**METROPOLITAN GOVERNMENT OF NASHVILLE AND DAVIDSON COUNTY**

**STAFF RECOMMENDATION**  
**207 Gentry Avenue**  
**October 15, 2014**

**Application:** New construction—addition and infill; Partial demolition  
**District:** Eastwood Neighborhood Conservation Zoning Overlay  
**Council District:** 06  
**Map and Parcel Number:** 08306020500  
**Applicant:** Andrew Beairo, Gentry Partners  
**Project Lead:** Melissa Baldock, melissa.baldock@nashville.gov

**Description of Project:** Application is to demolish a non-contributing addition and construct a new addition to a contributing structure (207 Gentry), three infill houses, four garages, and six rear lot cottages as part of a cottage development.

RESIDENCE # 1

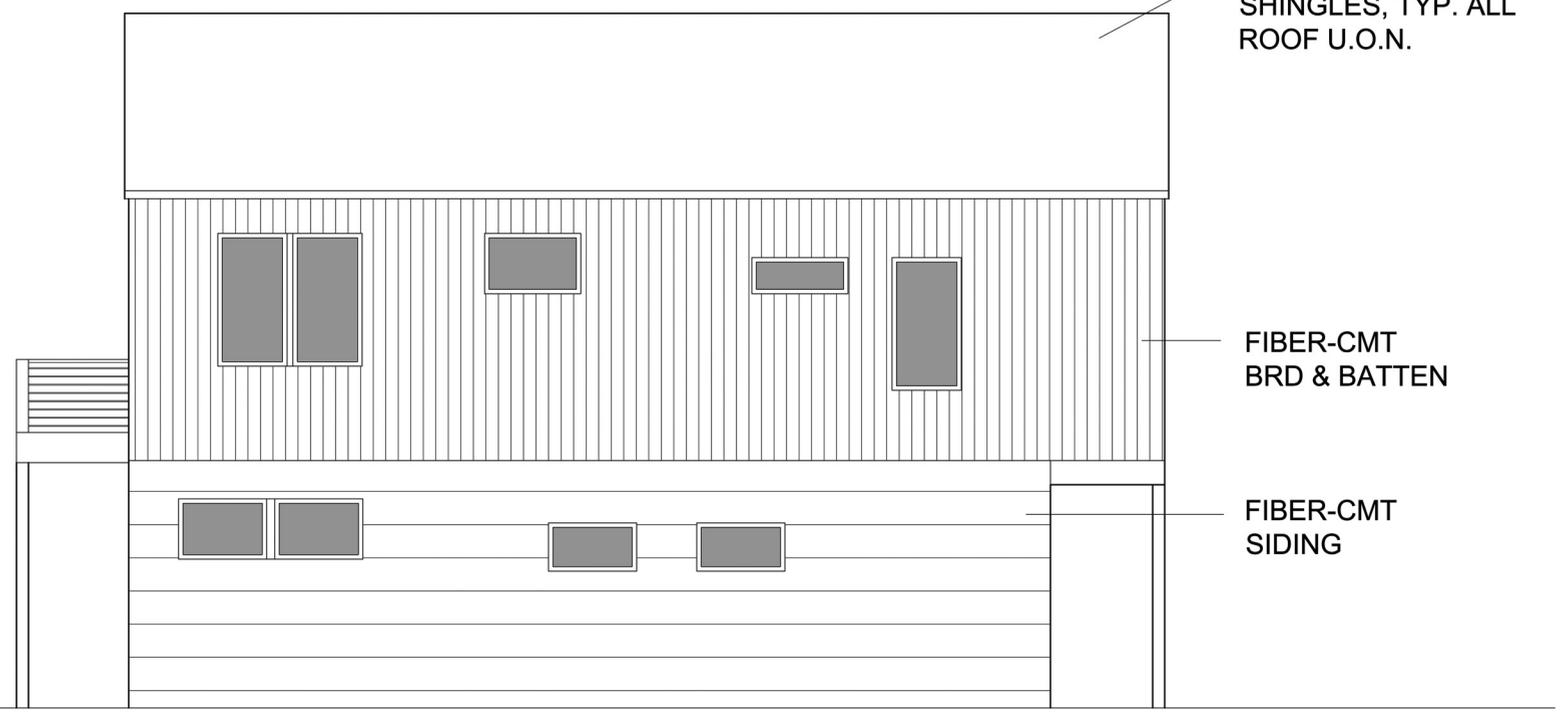
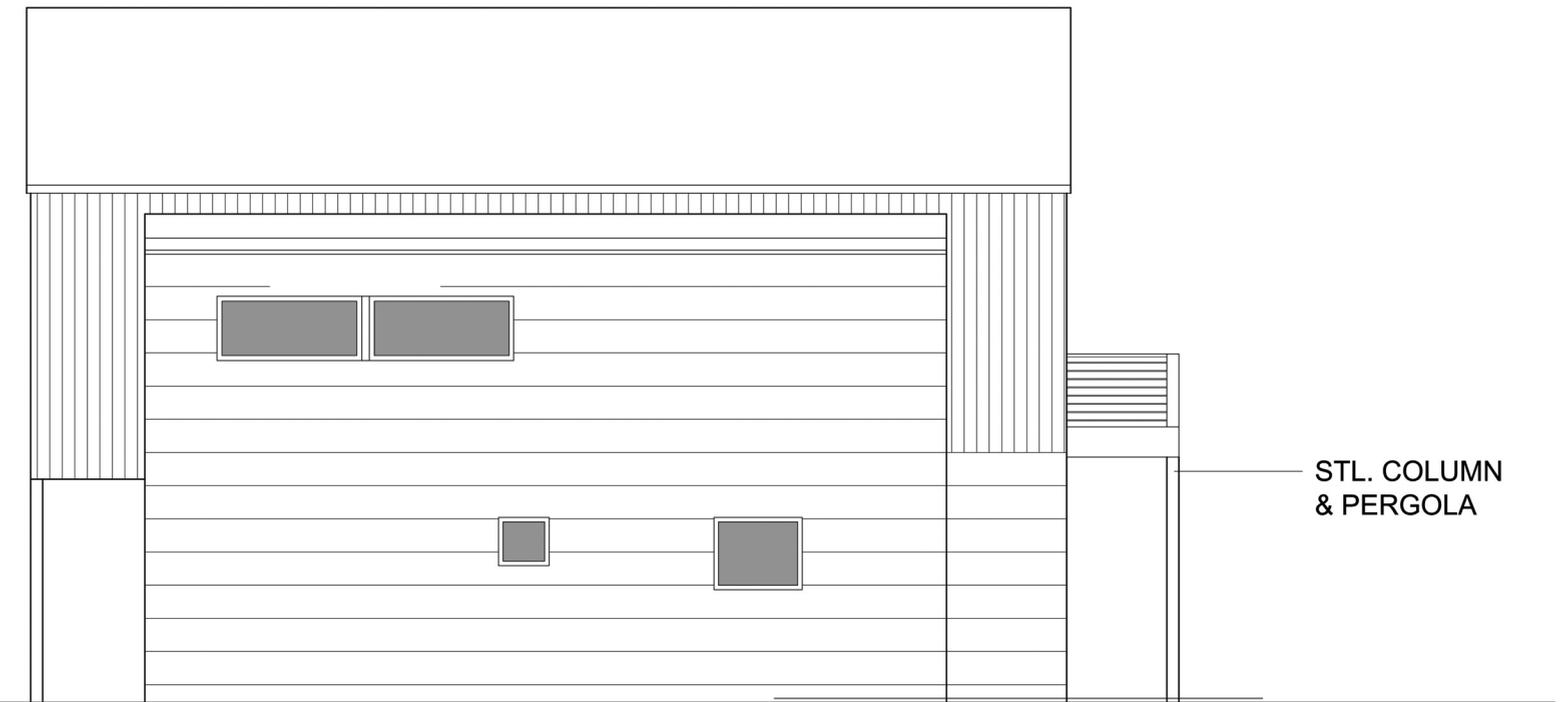
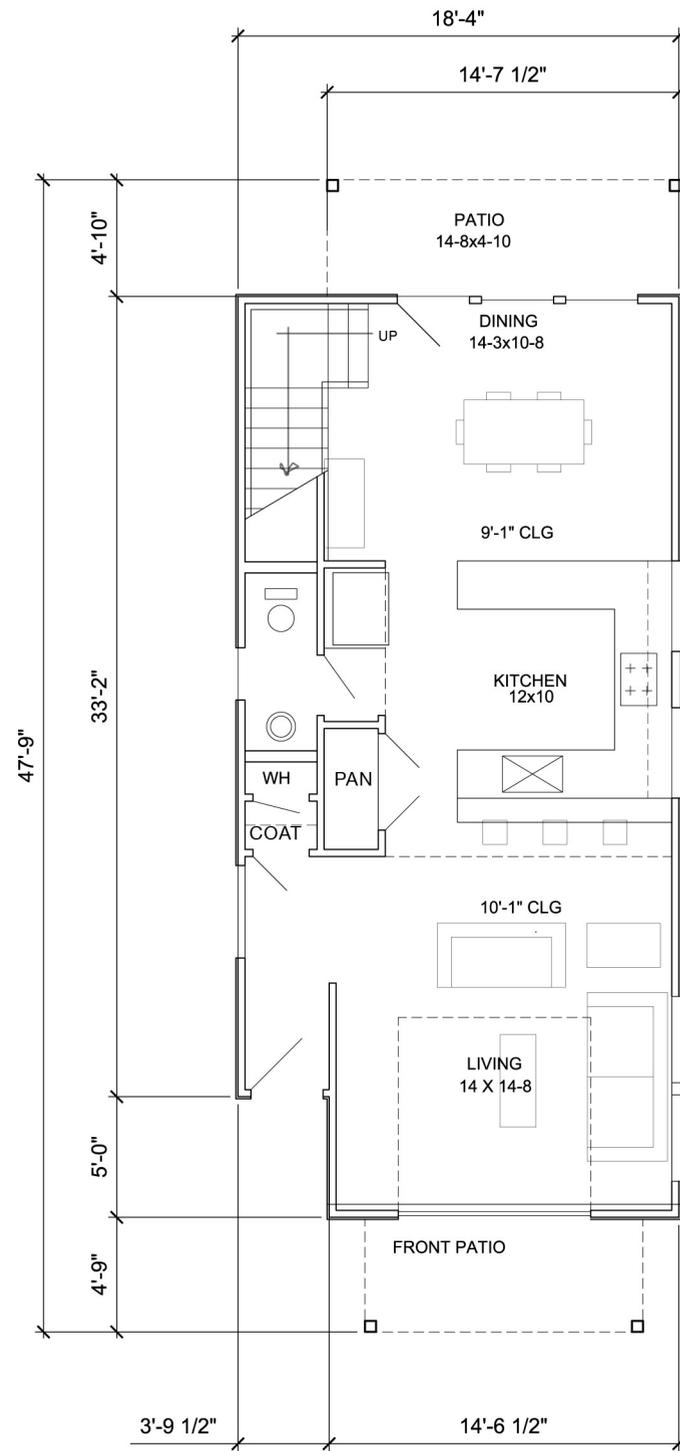
Houses 2 and 4 will have a concrete block foundation, and staff asks that the block be split faced. House 1 will have a brick foundation, with brick walls above. Even if the foundation line is delineated with a soldier course, herringbone pattern, or other change in brick layout, staff finds that this does not meet the design guidelines. The design guidelines state that there should be a change in material from the foundation to the wall above. In the past, the Commission has disapproved brick to grade like what is proposed here.

On House 1's side facades, the windows towards the front of the house (one on the right façade and two on the left façade) should be enlarged so that they are three feet (3') tall rather than two feet (2') tall. On House 2's right side facade, the two windows in front of the bay should be enlarged so they are at least three to four feet (3' – 4') tall and vertically oriented. On House 2's left façade, the triple window opening should likewise be elongated so that the windows are three to four feet (3' – 4') tall and vertically oriented. Similarly, on House 4's right side facade, the two windows towards the front should be enlarged so they are at least three to four feet (3' – 4') tall and vertically oriented, and on its left façade, the triple window opening should be elongated so that the windows are three to four feet (3' – 4') tall and vertically oriented.

1. On House 1, there be a change in material from the foundation to the wall above;
2. On House 1, the side dormers be set back a minimum of two feet (2') from the wall below.

3. The windows on the side facades of Houses 1, 2, and 4 be vertically oriented, and at least three feet (3') tall;
4. The finished floor heights of the three new houses facing Gentry Avenue be consistent with the finished floor height of existing historic house at 207 Gentry, to be verified by MHZC staff in the field;
